**ONSITE SANITATION** City of Portland – Bureau of Development Services  
1900 SW 4<sup>th</sup> Avenue, Portland, Oregon 97201 – 503-823-6892 – TTY 503-823-6868 – www.portlandoregon.gov/bds  
**SEPTIC REVIEW CERTIFICATION (Land Use/Planning)**

Description of proposed work for this Septic Planning Review Construct a water filtration facility including administration and maintenance buildings, treatment process structures such as filters, basins, and clearwell, as well as general, chemical, and equipment storage.

22-160016-SE

PROJECT: Bull Run Filtration Facility  
SHEET NO: 05-C-807  
GRID: 07

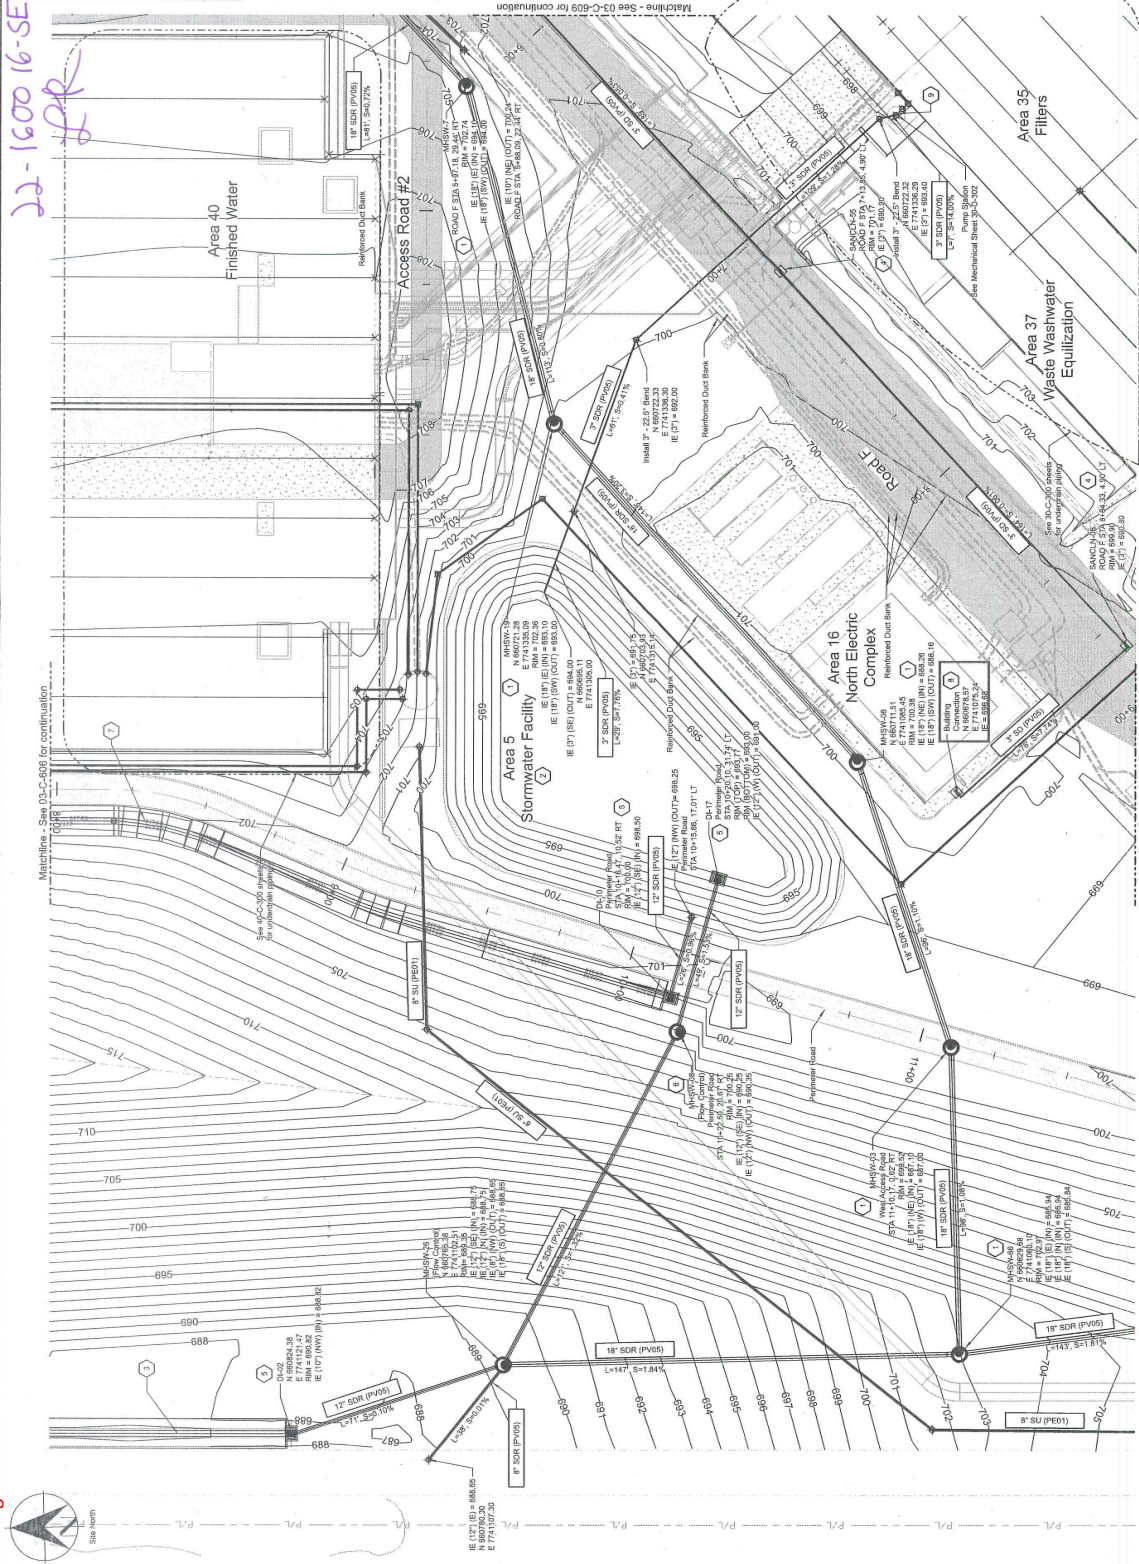
Sewage compliance design submitted for review of connectivity and general arrangement only, and for approval of drainfield sizing and location.

Design by Drawn by Checked by Project Mgr	Program Mgr Coord. Mgr Comm. Supv Date	09/02/22	Warning If this bar does not fit on the drawing it is not to scale
		FROM FOREST TO FAUCET	
Bull Run Filtration Facility Civil Utilities Grid 09		Stantec Project No. W02229 3785 / 3786 03-C-006 XX XX

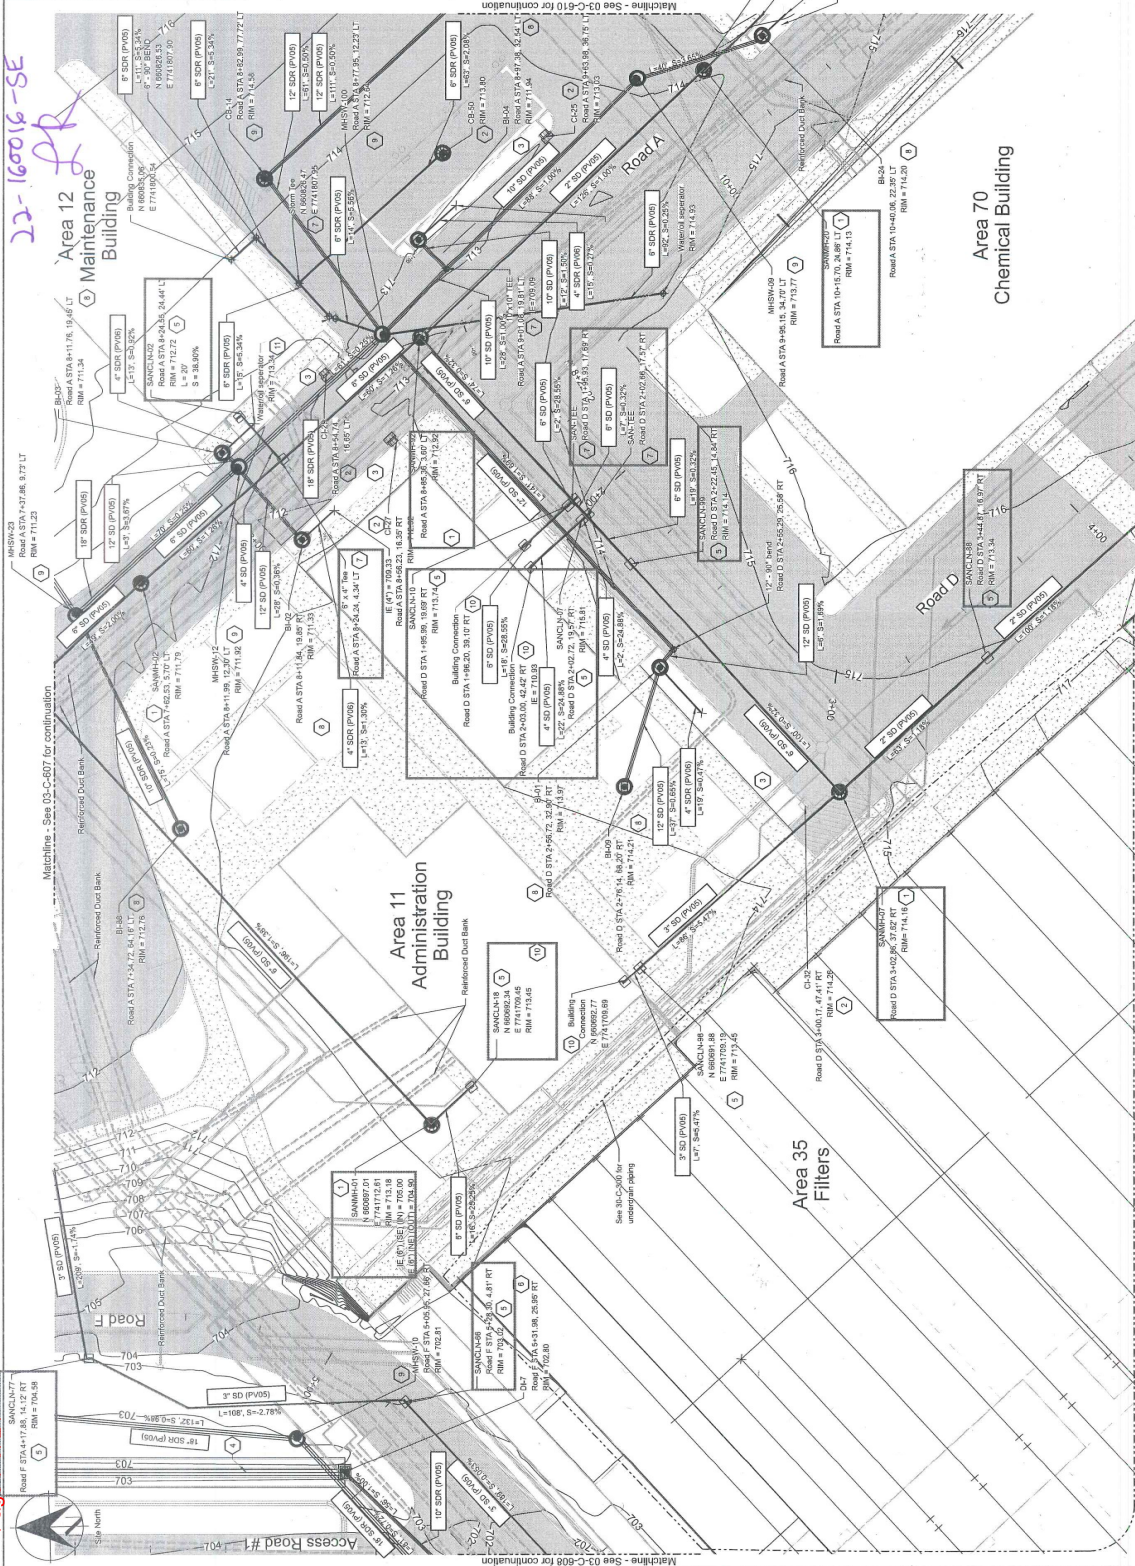
Sewage conveyance design submitted for review. This design is preliminary and for approval of drainfield sizing and location.

SAP Project No	W02229
1st Section	3765 / 3766
Sheet No	03-C-610
	XX XX

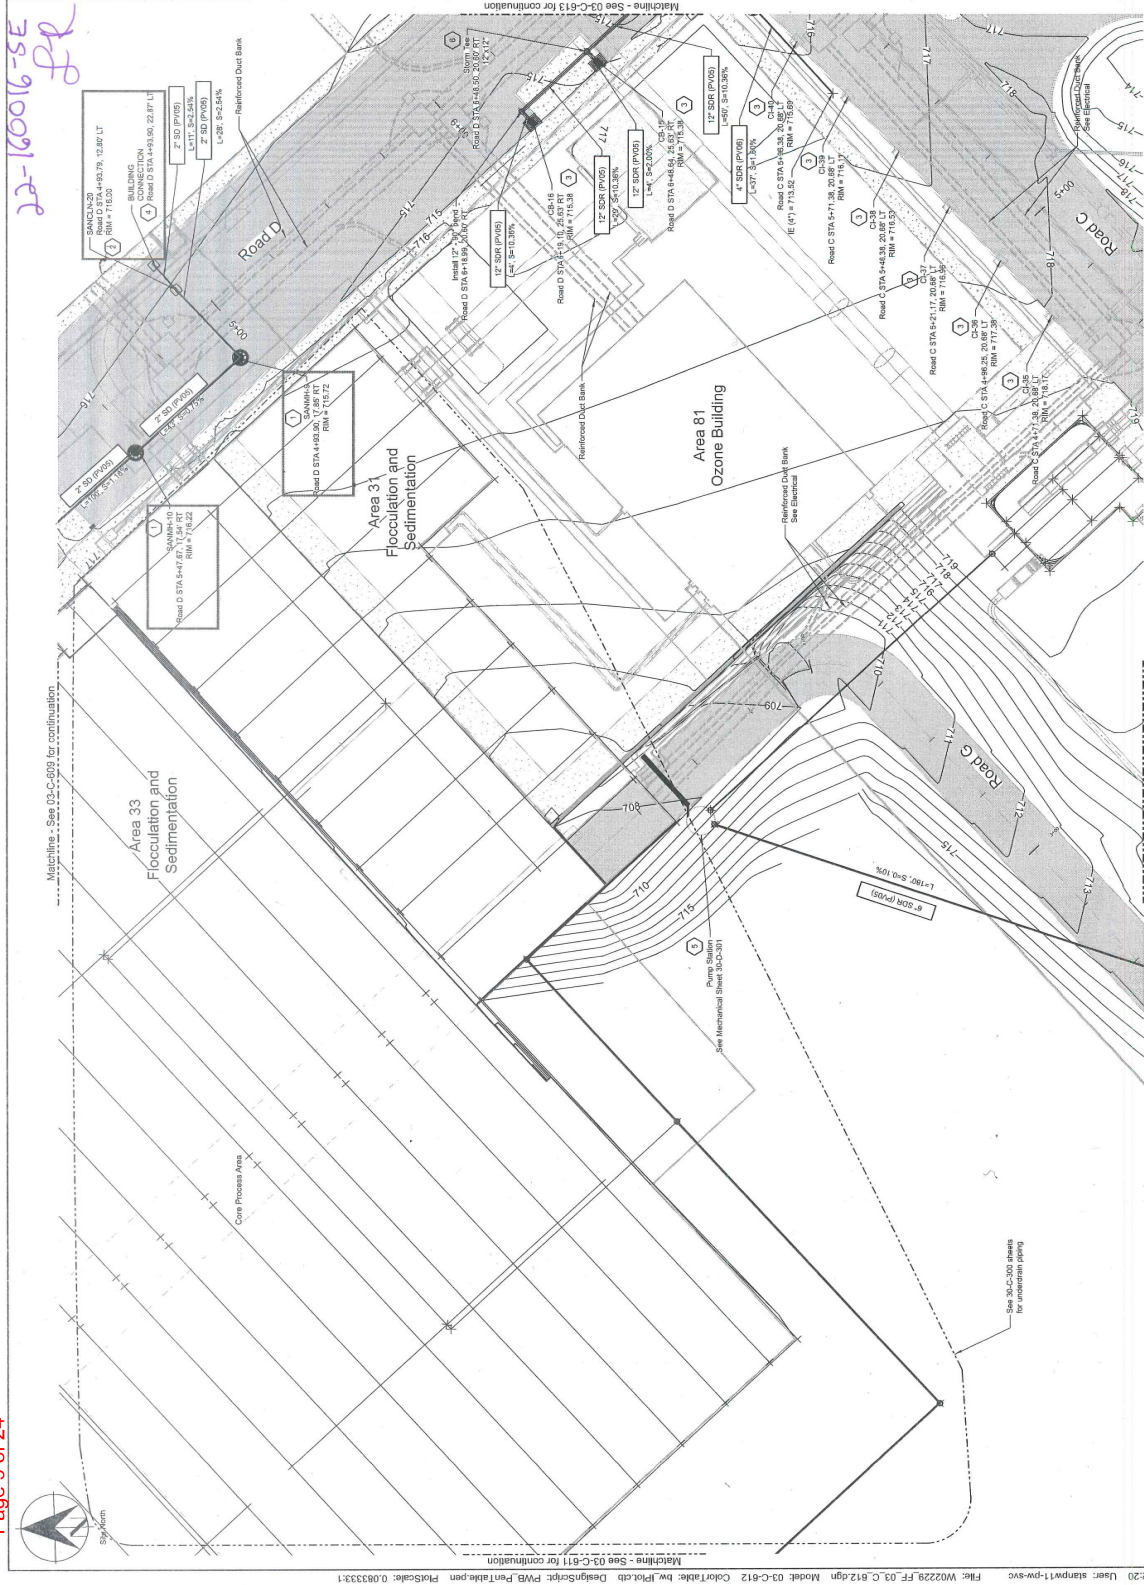
Sewage conveyance design submitted for review of connectivity and general arrangement only, and for approval of granted staging and location.

SHEET No	W02229
USE SECTION	3785 / 3786
SHEET No	03-C-612
DATE	XX XX

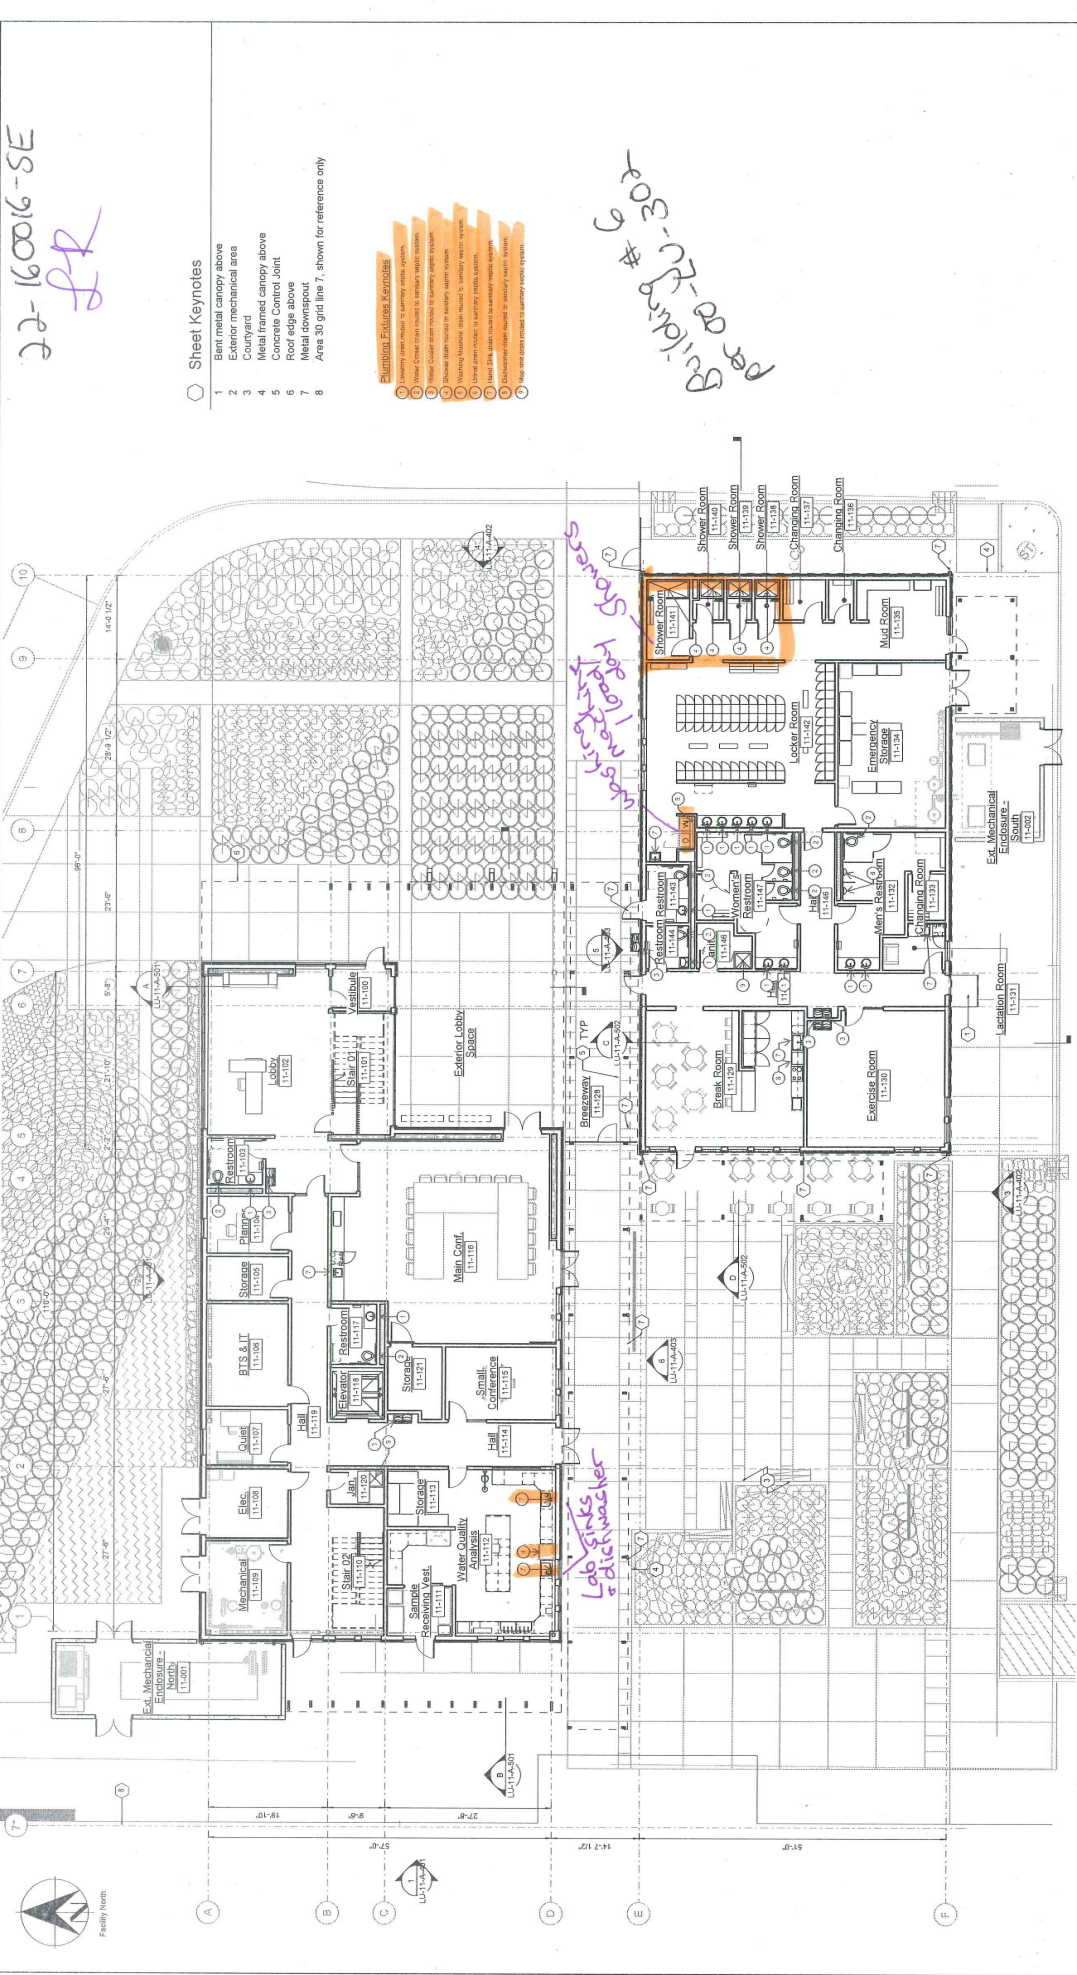
Sewage conveyance design submitted for review of connectivity and general arrangement only, and for approval of drainfield sizing and location.

Second Floor - Offices/Lab  
 SCALE: 1/8" = 1'-0"

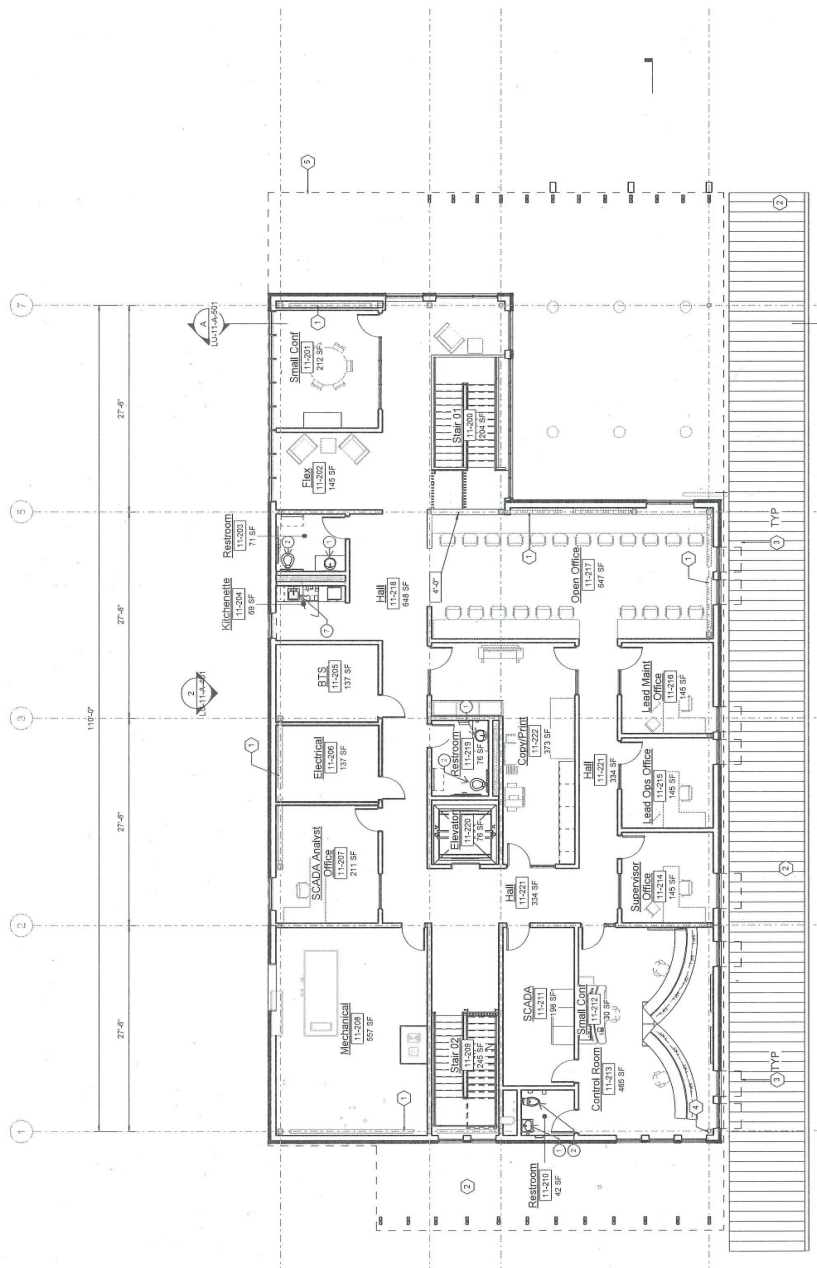
All Plumbing fixtures  
 this floor office visit  
 case

1 HVAC Mezzanine  
SCALE: 1/8" = 1'-0"

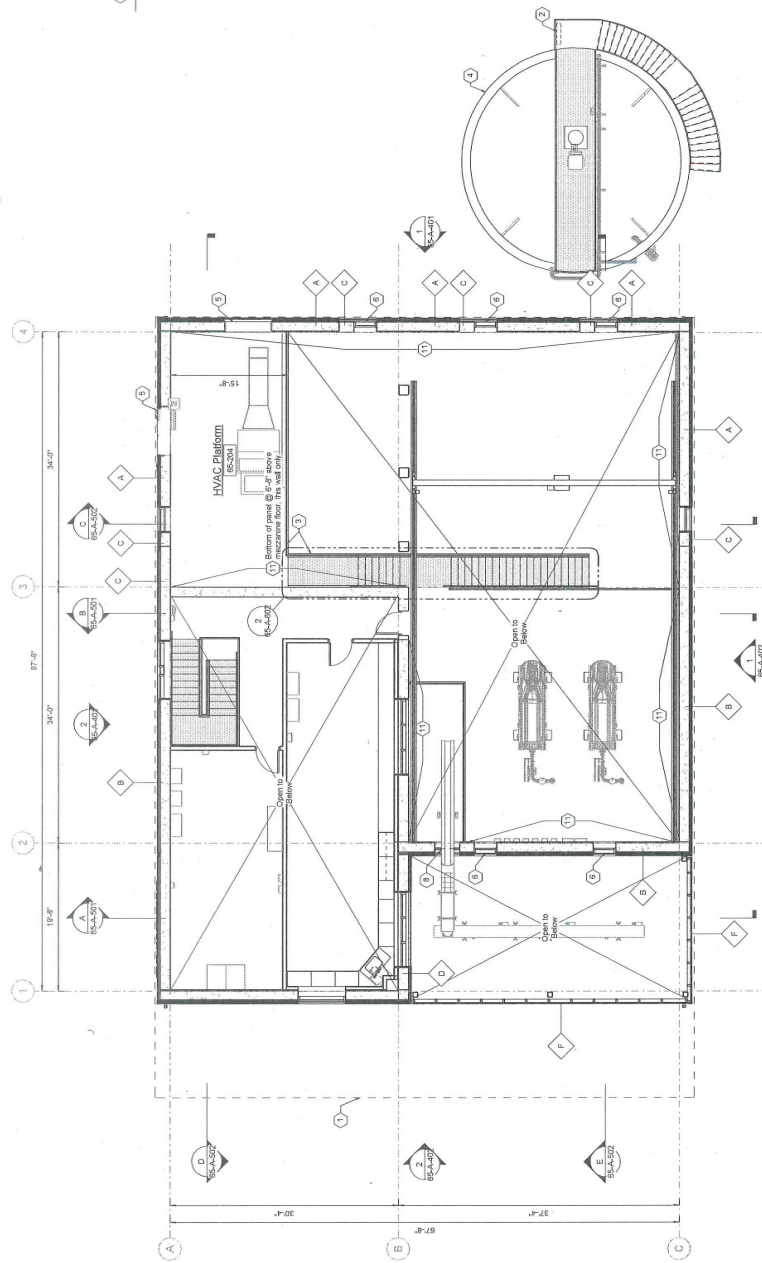
No Plumbing/Sanitary  
Level 3
